Subject: Specification of service life limitations for the brake hoses of the hydraulic wheel brake

Applicability: **ASW 28**; all models¹; Type-Certificate EASA.A.017; all serial numbers
ASW 28-18 E; Type-Certificate EASA.A.034; all serial numbers

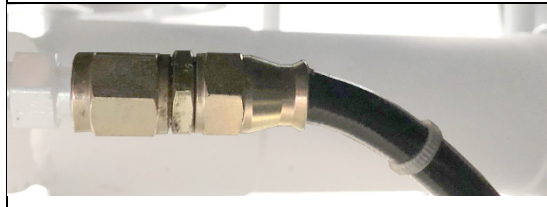
Brake hoses of the old type are made from rubber material and have a service life limitation. The material of the new type brake hoses is long-term resistant against the used brake fluid and thus no service life limitation is necessary.

Brake hoses of the **old type** made from rubber material, identifiable by the shown fitting shape and the textile fabric wrapping of the hose.

Brake hoses of the **new type**, identifiable by the shown fitting shape.

Brake hoses of the **old type**: This brake hose has to be exchanged in regular intervals of 6 years. If the brake hose is in good condition, it is not necessary to exchange the hose. Operation on condition requires the inspection of the hose for proper condition at least every 100 h.

Brake hoses of the **new type**: This brake hose has no service life limitation (on condition).
